Access Compliance Report Public Rights-of-Way (Pedestrian Signals)

Main Street: **OSO_PKWY** Cross Street: **OSO_PKWY** Location: **NE**

ADA ID: **SGRK211021124423** Signal Type: **One Push Button-APS** Overall Compliance: **No** Severity Scores: **BTN 1: 25** **BTN 2: N/A** **No BTN: N/A**

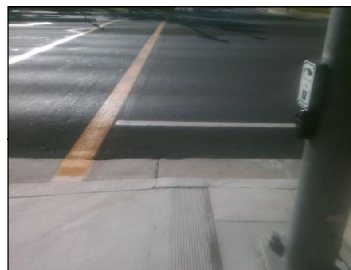
OC Std/PROW: MUTCD 4e.08, R404.2

Possible Solutions: Replace Signal Push Button With APS Button. Remove & Relocate Sign.
